## CONNECTICUT SITING COUNCIL

RE: **PETITION NO. 1234** - SolarCity Corporation petition for a declaratory ruling that no Certificate of Environmental Compatibility and Public Need is required for the proposed construction, maintenance and operation of a 2.8 Megawatt Solar Photovoltaic Electric Generating facility located at Becton, Dickinson & Company, 7 Grace Way, North Canaan, Connecticut.

**Petition No. 1234**  
**SolarCity Corporation**  
**7 Grace Way, North Canaan**  
**Staff Report**  
**July 21, 2016**

Figure 2 - Vernal Pool Analysis Map

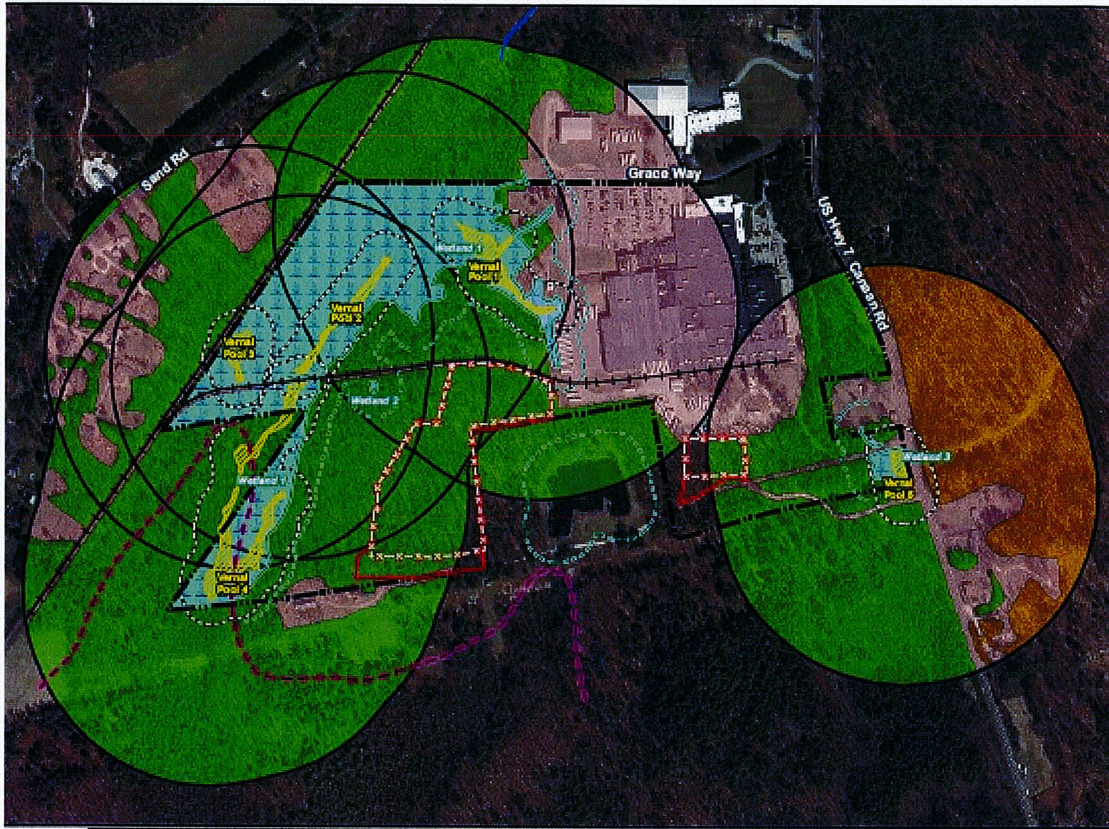
A total of five vernal pools were identified. All five vernal pools were cryptic vernal pools embedded within larger wetland systems. Vernal Pools 1 through 4 are embedded within Wetland 1, and Vernal Pool 5 is embedded within Wetland 3. All five vernal pools meet the biological criteria of Tier 1 vernal pools under the Calhoun and Klemens 2002 Best Development Practices – Conserving Pool-Breeding Amphibians in Residential and Commercial Developments in the Northeastern United States (2002 BDPs). The five vernal pools have existing development within their 100-foot Vernal Pool Envelopes (VPE). Vernal Pools 1 through 5 have existing percent development in the VPEs of 25 percent, 5 percent, 10 percent, 2 percent, and 37 percent, respectively. However, no additional development is proposed within the VPEs for Vernal Pools 1 through 5. The area ranging from 100 feet to 750 feet from a vernal pool is known as the Critical Terrestrial Habitat (CTH). The 2002 BDPs require limiting development to not more than 25 percent of the CTH area. See Vernal Pool CTH table below.

Accordingly, Vernal Pools 2 through 5 are compliant with the 2002 BDPs because the percentages of post-development areas to their CTH areas are all less than 25 percent. However, Vernal Pool 1 is not compliant because the total post-development would be 42 percent of the CTH area. See attached Figure 2.

**Figure 3 - Vernal Pool Mitigation Plan**

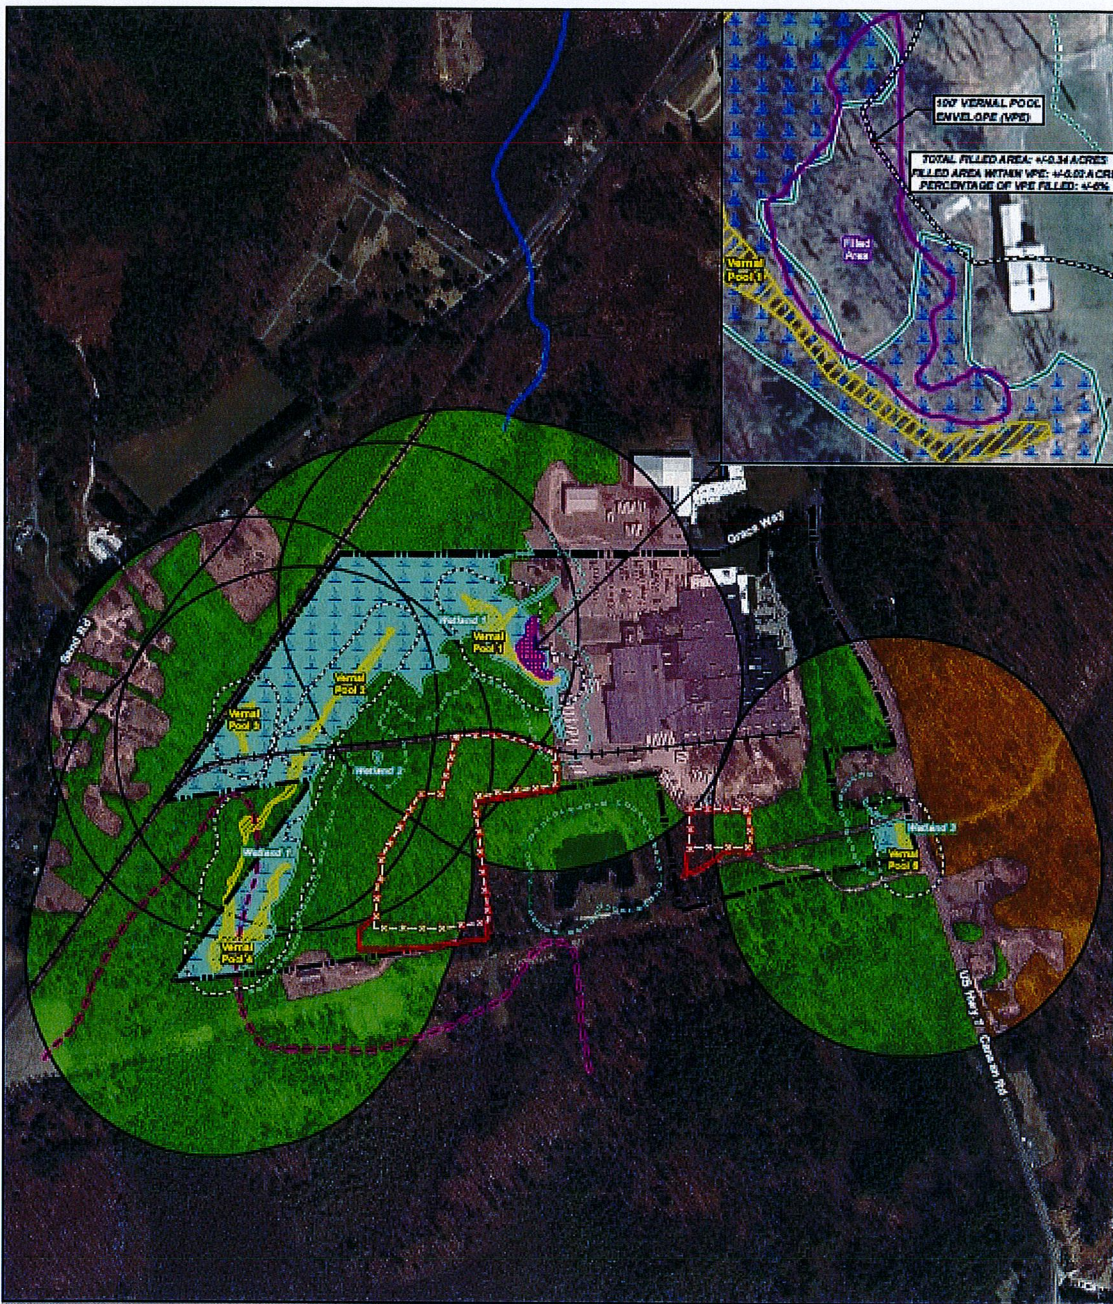
To compensate for the additional development in the Vernal Pool 1 CTH, the Petitioner is proposing a Vernal Pool Mitigation Plan (VPMP). The proposed VPMP strategy is to improve these historically filled wetland areas bordering Vernal Pool 1, which contains existing impacts within the eastern portions of both the VPE and the CTH, primarily in the form of existing development associated with the BDC facility. The Petitioner notes that, per the 2002 BDPs, the first 100 feet bordering a vernal pool is the most critical for protection. Areas bordering Vernal Pool 1 were overlain with spoils likely originating from the digging of a drainage ditch that feeds the wetland system supporting this resource. Enhancement of historically filled wetland areas bordering Vernal Pool 1 would include the spreading/leveling of any large fill piles placed in Wetland 1. (See attached Figure 3.) Any mature trees would be protected during the enhancement. Existing invasive shrubs

would be treated and eradicated prior to the planting of the enhancement area. In addition, considering that these filled areas are compacted, the surface would be broken up using a tiller or suitable alternative to allow for easier plant growth. In areas where trees will be planted, additional placement of topsoil will be utilized to assist plant tree survivorship.

Subsequently, upland forest plantings would be installed throughout the enhancement area to stabilize and re-vegetate the affected areas. A planting plan would be developed under the direction of an environmental professional experienced in wetland mitigation/enhancement that would promote the regeneration of the terrestrial forest habitat. Enhanced terrestrial areas would be protected by a leaf, straw or other suitable alternative mulch and under sown with the seed mix “New England Conservation Seed Mix” or an approved substitute. In addition, signage would be installed at the edge of the enhancement areas identifying them as protected and sensitive to promote the prevention of potential future impacts and degradation.
